ATTACHMENT A

Consideration of Approval of Miniwall S5 and NPA Extraction Plan

Figure 2 – Seagrass protection barrier and 20 mm vertical subsidence contour

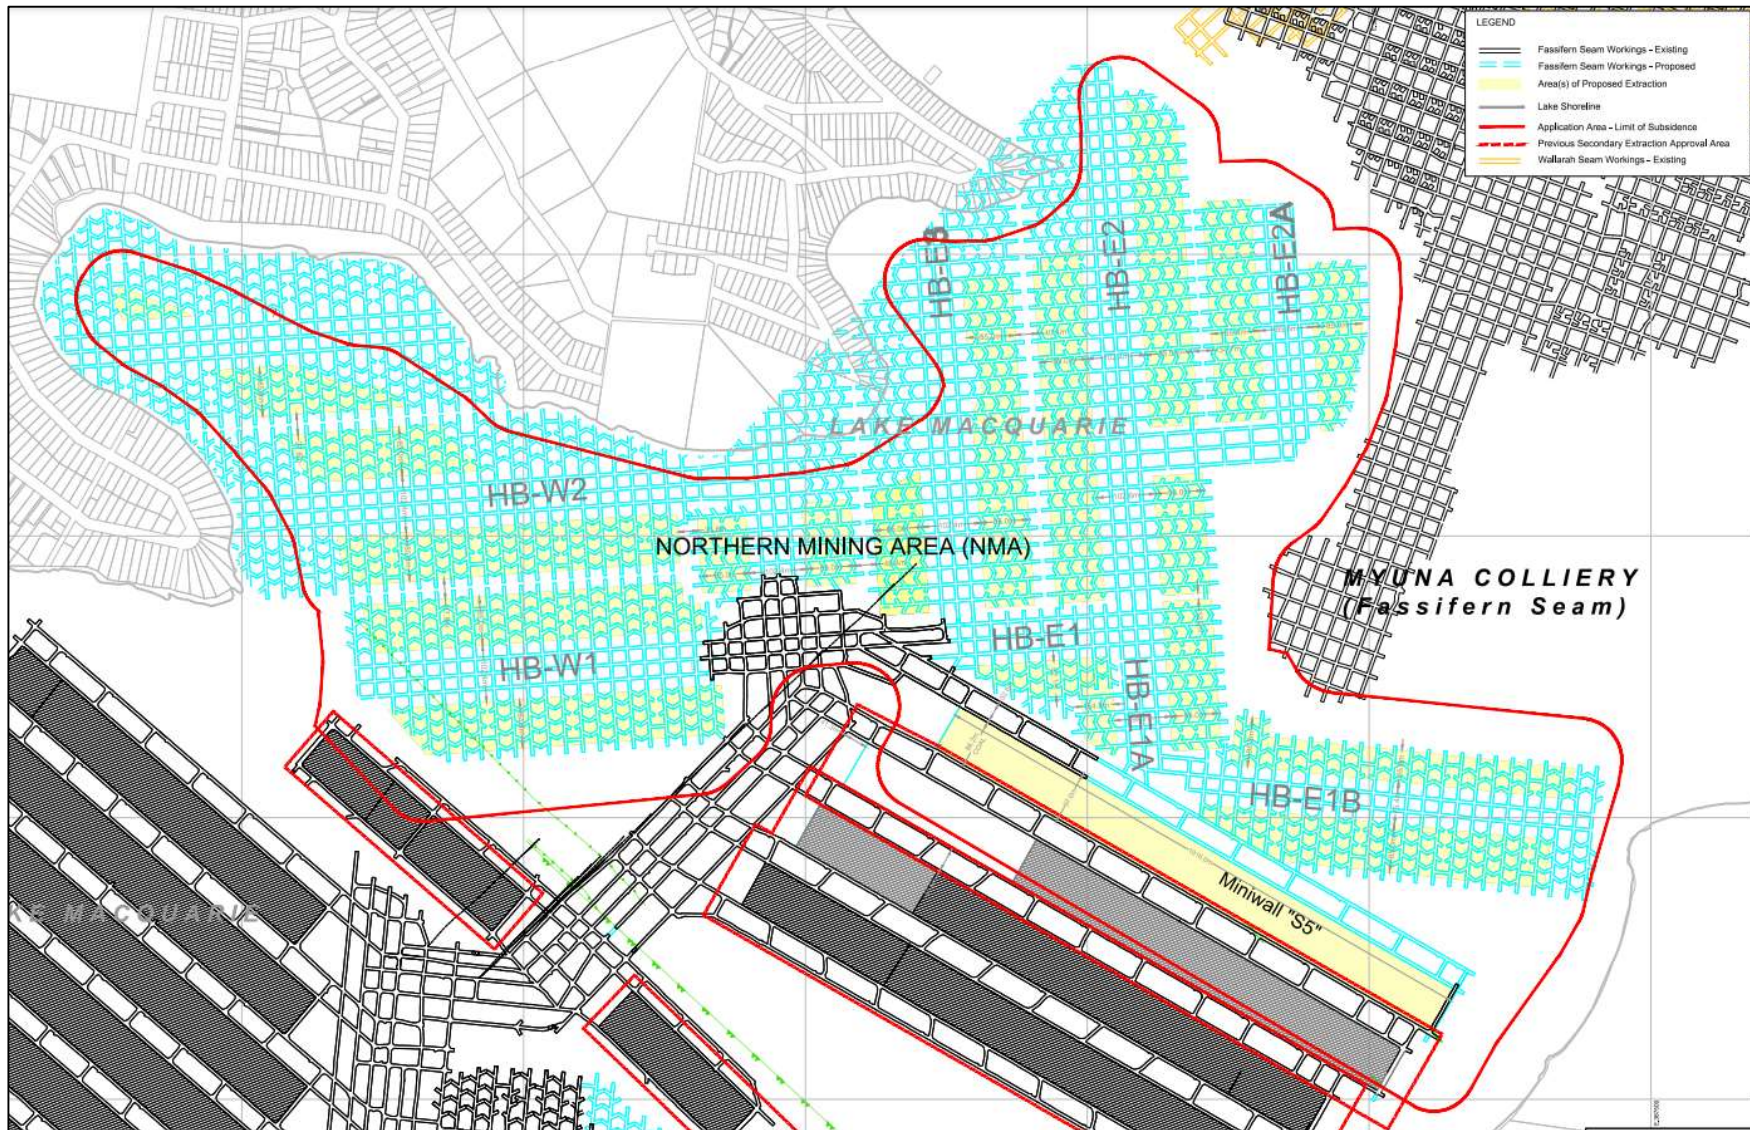
11. The SPB is similar to the HWMSB, only that its purpose is to protect seagrass beds that fringe the foreshore and extend to a depth of two metres within the lake. The line from the lakeside edge of the SPB is projected at an angle of 26.5 degrees to its intersection with the target coal seam. No secondary coal extraction is permitted within this zone. The figure below shows that the 20 mm subsidence contour (in red) skirts the seagrass beds.

At CVC, for the assessment of the EP for Miniwall S5 and the NPA, the SPB lies completely within the HWMSB. That is, if the HWMSB is protected from secondary extraction, the SPB is also protected.

Delta Coal has provided a mine plan for Miniwall S5 and the NPA based on the avoidance of secondary extraction within both the HWMSB and the SPB. Therefore, the proposed mining layout would comply with the requirements for the protection of these sensitive features.
